Access Compliance Report

Public Rights-of-Way

Intersection ID: 30318	Main Street: CANNONBALL_DR	Cross Street: SHINKANSEN_DR	Location:	N
ADA ID: EFACF72C5FC5	Ramp Type: PerpDiag	Initial Pass/Fail: Fail	Overall Compliance: No	Severity Score: 10

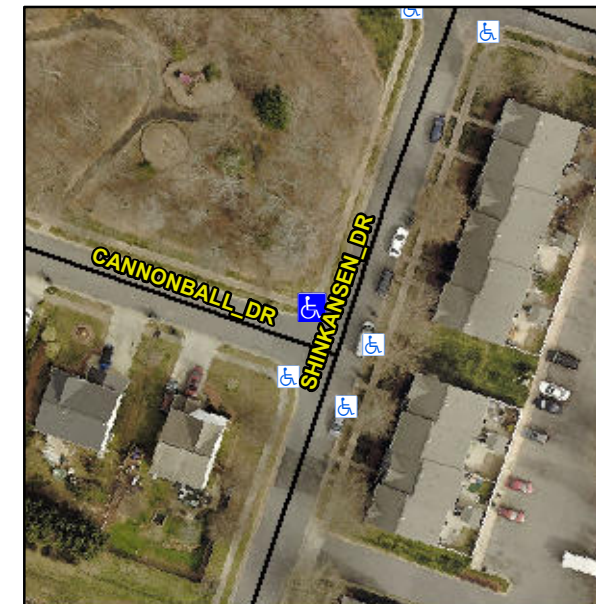
Not Found, R304.5.1, R304.5.3

Compliance	Description	Data	Compliance	Description	Data
N/A	Ramp Length (in)	44.5	Yes	Ramp Slope (%)	5.3
No	Ramp Width (in)	42.0	No	Ramp XSlope (%)	4.0
N/A	Flare Type LT	N/A	N/A	Flare Type RT	N/A
N/A	Flare Slope LT (%)	N/A	N/A	Flare Slope RT (%)	N/A
N/A	Flare Traversable LT?	N/A	N/A	Flare Traversable RT?	N/A
N/A	Landing Length (in)	N/A	N/A	DWS Provided?	N/A
N/A	Landing Width (in)	N/A	N/A	DWS Contrast?	N/A
N/A	Landing Slope (%)	N/A	N/A	DWS Length (in)	N/A
N/A	Landing X Slope (%)	N/A	N/A	DWS Full Width?	N/A
N/A	Landing Curb? (Y/N)	N/A	N/A	DWS Offset (in)	N/A
N/A	Shared Landing?	N/A			
N/A	Gutter Ponding?	N/A	N/A	Gutter Slope (%)	N/A
N/A	Gutter Lip Ht (in)	N/A	N/A	Gutter X Slope (%)	N/A
N/A	Painted X Walk1?	No	N/A	Painted X Walk2?	No
	X Walk 1 Direction	To SW		X Walk 2 Direction	To SE
N/A	X Walk 1 Width (in)	N/A	N/A	X Walk 2 Width (in)	N/A
	X Walk 1 Slope (%)	2.5		X Walk 2 Slope (%)	6.3
	X Walk 1 X Slope (%)	6.6		X Walk 2 X Slope (%)	0.5

Remove & Replace Curb Ramp With Two New Directional Ramps or Equivalent.
